## FORMAL OBJECTION

SSD 80626208 — 8–10 New McLean Street, Edgecliff

*Demolition, Two-Lot Torrens Subdivision & 65-Apartment Residential Flat Building*

**Merrill Witt**

Figure 25: Extract from the Post-exhibition Report by DPHI for PP-2023-1648 with the proposed built form on the western portion of the site shown on the left

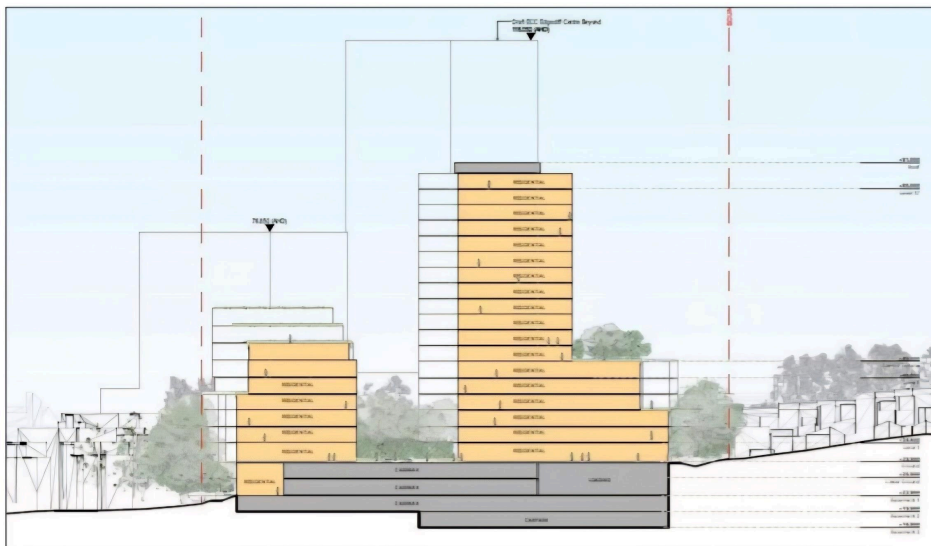
The building's common wall at Levels 1–4 is designed specifically for physical integration with a future eastern building. Without Stage 2, this wall is a permanent blank fire-rated facade — a built-form outcome that cannot be remedied by any condition of consent.

The Level 5 communal open space (355m<sup>2</sup>) is designed to link to the future eastern lot. Without the eastern building, it functions as an isolated rooftop terrace rather than the integrated communal amenity the design assumes.

The ground-level communal space is described in the Planning Ingenuity's Environmental Impact Statement (EIS) as an undercroft in the southern corner of the building. Its solar access and therefore likely usefulness to the residents is entirely unanalysed.

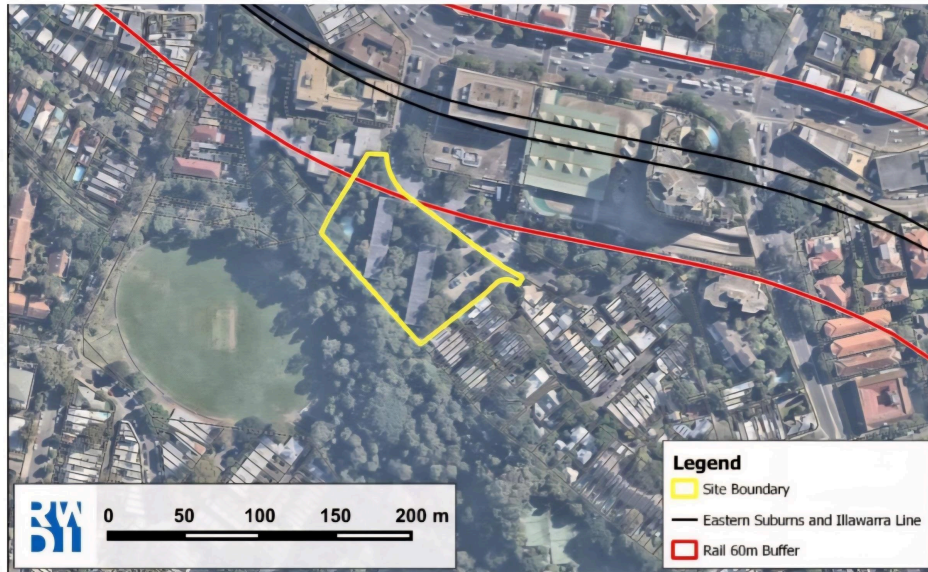
Table 2 of the Urban Arbor Arboricultural Impact Assessment indicates that 152 of 203 assessed trees are recommended for removal. This includes 8 trees classified as Category AA (high retention value) and 49 trees classified as Category A (moderate retention value). Approximately two-thirds of the highest-value trees on the site — and the majority of trees of moderate retention value — are proposed to be removed.

The scale of removal indicates that the building and basement footprint have not been designed to respond to the existing vegetation, which serves as a valuable biodiversity corridor to Trumper Park. No alternative design with a reduced footprint was tested or presented. The ADG design guidance under 3E specifically recommends that basement car parking be consolidated beneath the building footprint to maximise deep soil and retain significant trees. Instead, extensive excavation for the over provision of car parking spaces will lead to the destruction of most of the existing tree canopy and provide only limited opportunities for deep soil landscaping.
